Access Compliance Report

Public Rights-of-Way

Intersection ID: 19908	Main Street: BROWN-GRIER_RD	Cross Street: GALLANT_LN	Location: NW
ADA ID: DCACEEF03AD4	Ramp Type: Directional1	Initial Pass/Fail: Fail	Overall Compliance: No
		Severity Score: 12.5

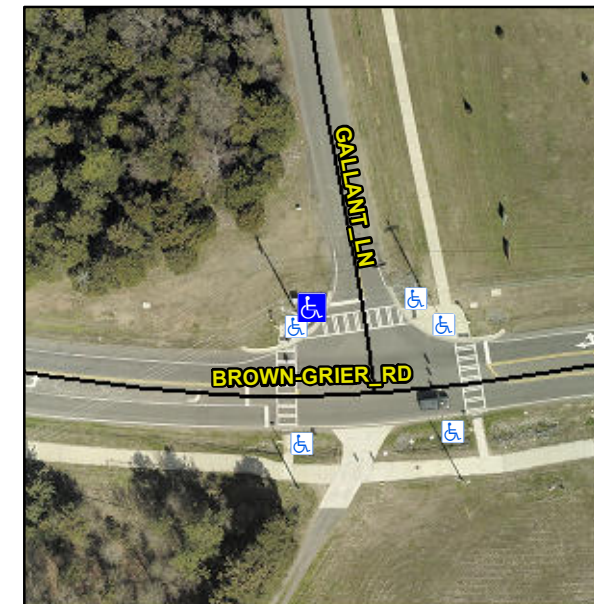
R304.5.3

Remove & Replace Entire Ramp.
